# CITY OF ALBUQUERQUE

RE: Lot 25 Block 1 Unit 22 SAD 228 8001 Canoncito Rd. NW Volcano Cliffs Subdivision Grading and Drainage Plan Engineers Stamp Date 1/17/2021 (D10D003N25)

# LOT 25 BLK 1 UN 22 VC 8001 CANONCITO DRIVE N.W. GRADING AND DRAINAGE PLAN

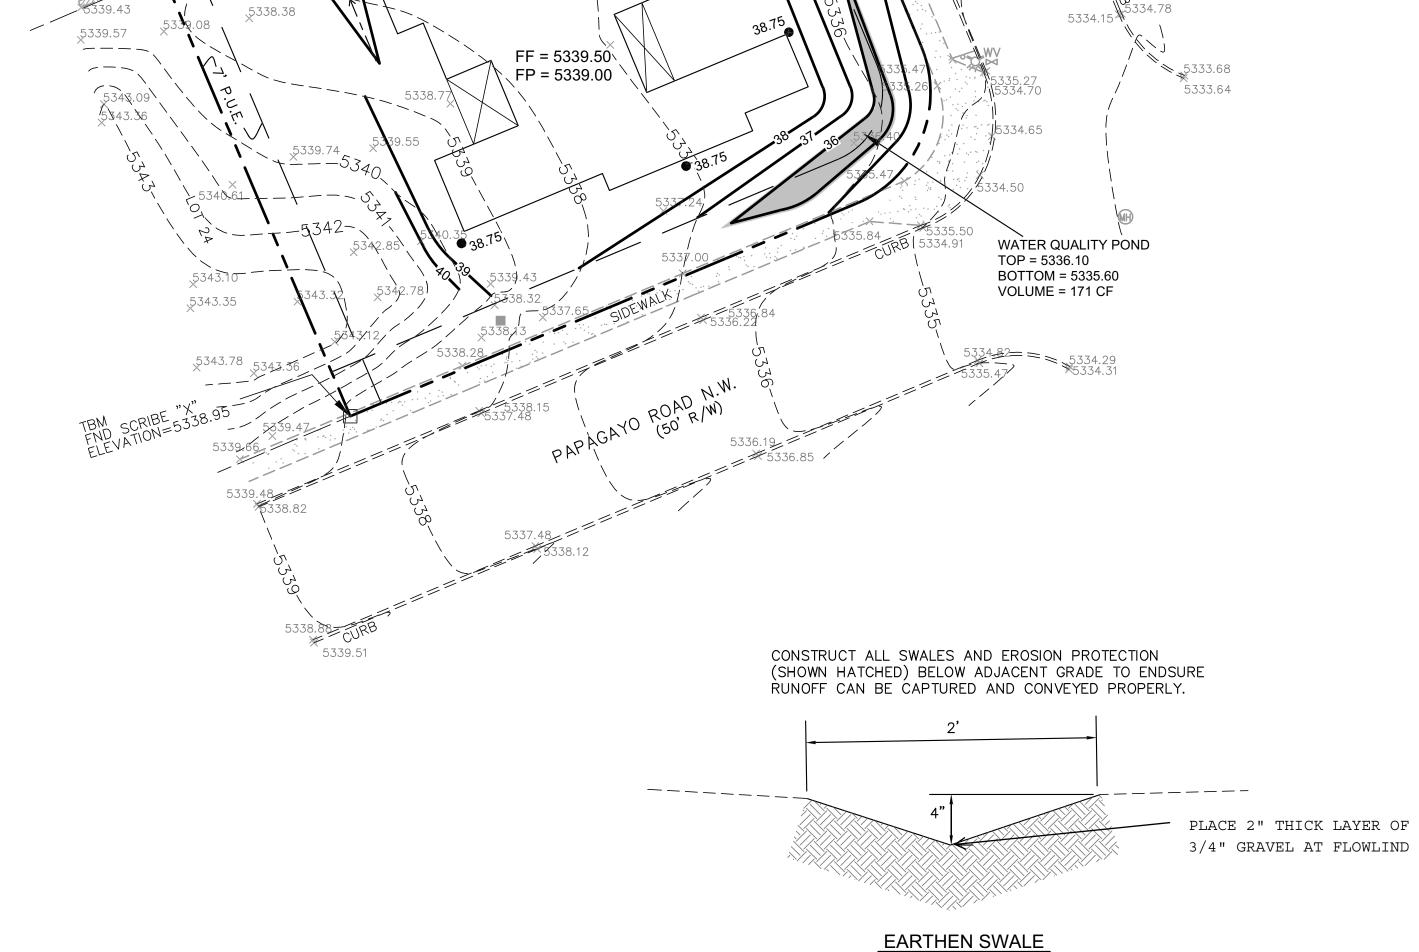
Based upon the information provided in your submittal received 12/17/2020, this plan is approved for Grading Permit.

Prior to Building permit approval a Pad Certification will be required, provided by the Engineer or a registered Land Surveyor.

Advise the owner contractor not to use dirt as a ramp to climb the curb, use lumber or crusher fines for this purpose.

Reiterate to the Owner/Contractor that a separate permit for a garden/retaining wall must be obtained with the approved G&D plan and Pad Certification. Also, if a swimming pool is to be placed the grading and drainage plan will change and will need to be resubmitted.

Prior to Certificate of Occupancy release, Engineer Certification per the DPM checklist is required.
